TRANS/WP29/GRSG/1999/12/Rev.1/Add.1
17 July 2001

PROPOSAL FOR DRAFT AMENDMENTS TO REGULATION No. 43
(Safety glazing)

Revision 1-Addendum 1

Transmitted by the Experts from Belgium and the United Kingdom

"Safety glazing having a regular light transmittance < 30 per cent

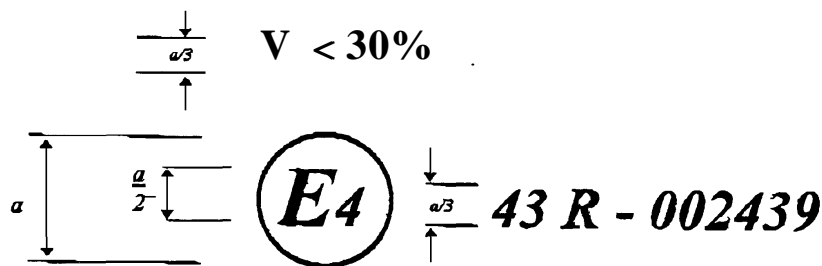
In addition, add, after the approval mark example for safety glazing having a regular light transmittance < 70 per cent, a new example of approval marks, to read:

The above approval mark affixed to a glass pane other than a safety glazing with a regular light transmittance of less than 30 per cent as determined by the test described in annex 3, paragraph 9.1, shows that the component concerned has been approved in the Netherlands (E 4) pursuant to Regulation No. 43 in its original form under approval No. 002439. The approval number indicates that the approval was granted in accordance with the requirements of Regulation No. 43."

"Rigid plastic glazing

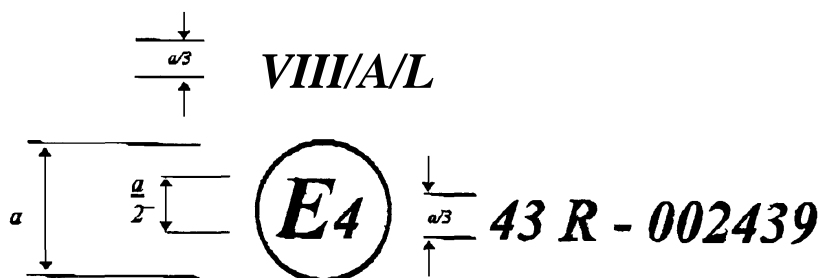
The approval mark example for rigid plastic glazings other than windscreens, amend to read:

The above approval mark affixed to a rigid plastic glazing pane for forward facing panels shows that the component concerned has been approved in the Netherlands (E 4) pursuant to Regulation No. 43 under approval No. 002439. The approval number indicates that the approval was granted in accordance with the requirements of Regulation No. 43 in its original form. The pane has been abrasion tested so that the outer surface meets the 2 per cent light scatter/1000 cycle requirement and the inner surface meets the 4 per cent light scatter/100 cycle requirement."
